HISTORIC AND DESIGN REVIEW COMMISSION

May 07, 2025

HDRC CASE NO: 2025-083
ADDRESS: 2053 W GRAMERCY PLACE – 2000, 1900 Blocks of W Gramercy
LEGAL DESCRIPTION: NCB 1932 BLK 39 LOT 14
ZONING: R-6, H
CITY COUNCIL DIST.: 7
DISTRICT: Monticello Park Historic District
APPLICANT: Emanuel Saldana/COSA Public Works
OWNER: N/A N/A/L CINCO INVESTMENTS LLC
TYPE OF WORK: Sidewalk Replacement
APPLICATION RECEIVED: March 28, 2025
60-DAY REVIEW: May 27, 2025
CASE MANAGER: Caitlin Brown-Clancy

2002 W Gramercy
Contributing Wall

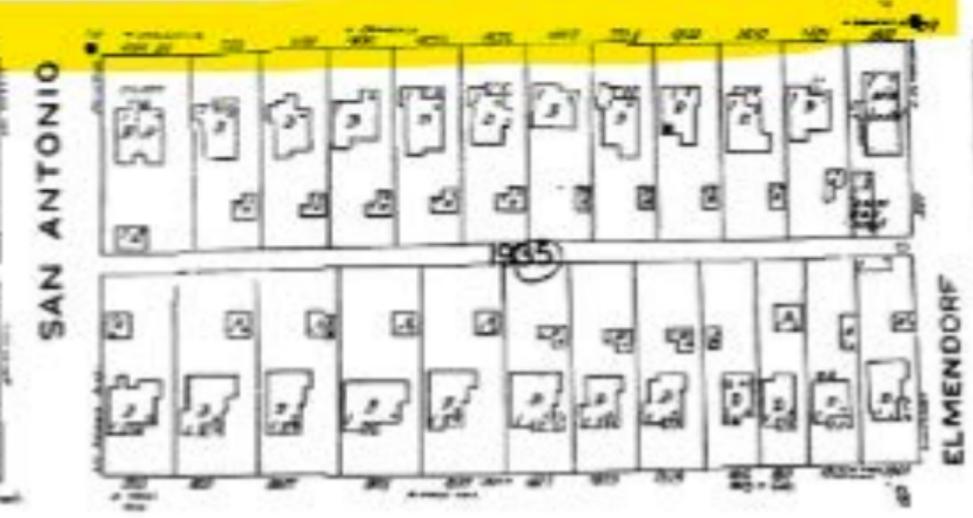
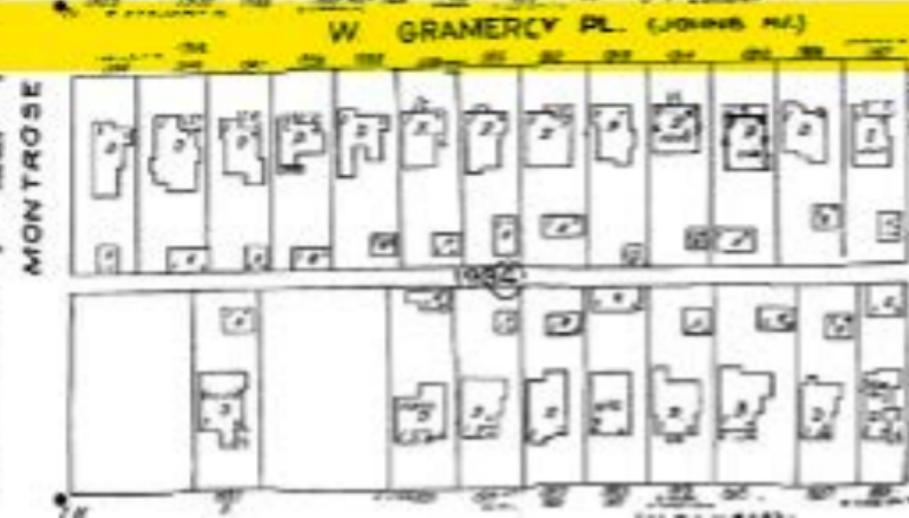
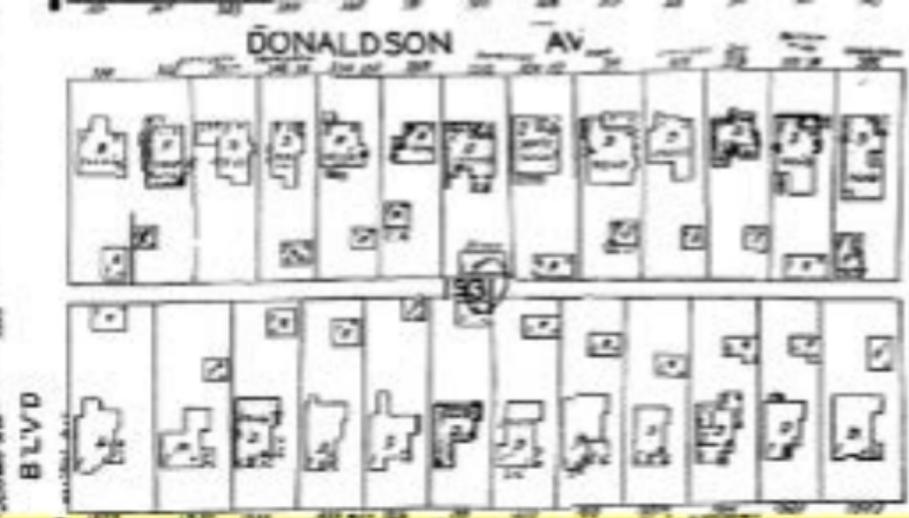
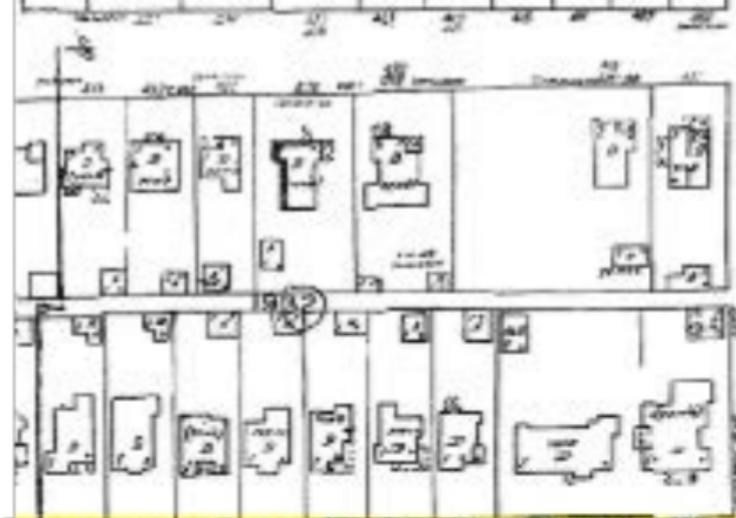
- f. **WALKWAYS & RETAINING WALLS** – The applicant is requesting to preserve or replace the existing walkways and retaining walls to some extent based on current condition. Guideline 5.A.ii states that every effort should be made to match the new walkways to existing in color, material, historic alignment, configuration and width. Guidelines 2.A.i and ii state that historic walls should be preserved and only deteriorated sections that are beyond repair should be replaced. Should replacement be necessary, every effort should be made to match existing materials (including mortar) to the color, texture, size, profile, and finish of the original. Staff finds the retaining wall at 2002 W Gramercy to be contributing and that every effort should be made to preserve the wall, however, should preservation not be feasible, staff finds the contractor should document the wall through photographs and field measurements prior to any demolition work to serve as reference during reconstruction.

4. Staff recommends the preservation of the seven (7) existing retaining walls and walkways over wholesale replacement. Should replacement be necessary, staff finds every effort should be made to only replace those sections deteriorated beyond repair with material (including mortar) to the color, texture, size, profile, and finish of the original with the following stipulation based on findings a and f. This should be documented by the contractor through photographs and field measurements prior to any demolition work.
